## INDEX TO NOP COMMENTS

**Table C-2  
Responses to the NOP Comments**

**NOTICE OF PREPARATION OF A DRAFT ENVIRONMENTAL IMPACT REPORT  
AND NOTICE OF PUBLIC SCOPING MEETING**

**Project Title:** VENOCO SOUTH ELLWOOD FIELD PROJECT

**Figure 4. Historic and Proposed Production from Platform Holly**

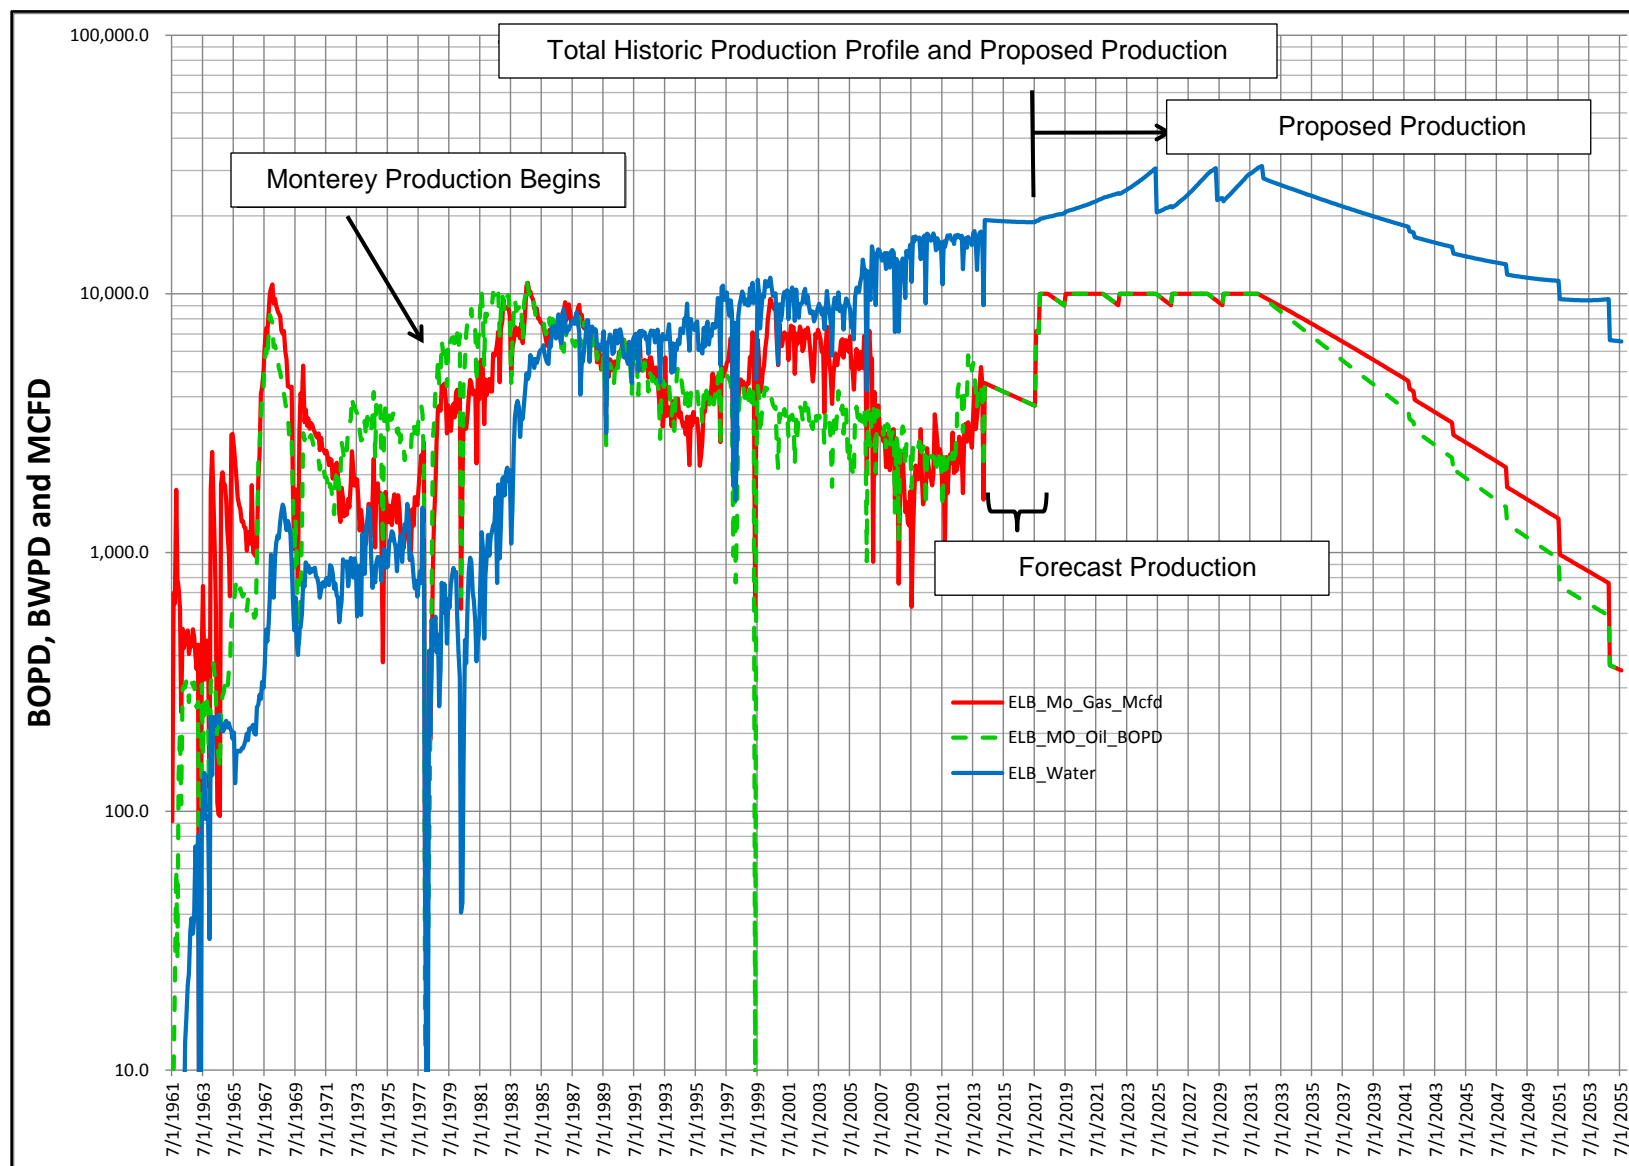
<b>5-3</b>	NOP Figure 4, <i>Historic and Proposed Production from Platform Holly</i> , has been omitted from the Draft EIR. Platform Holly capacities and production is discussed in Section 2.3., <i>Project Life</i> , of the Draft EIR.
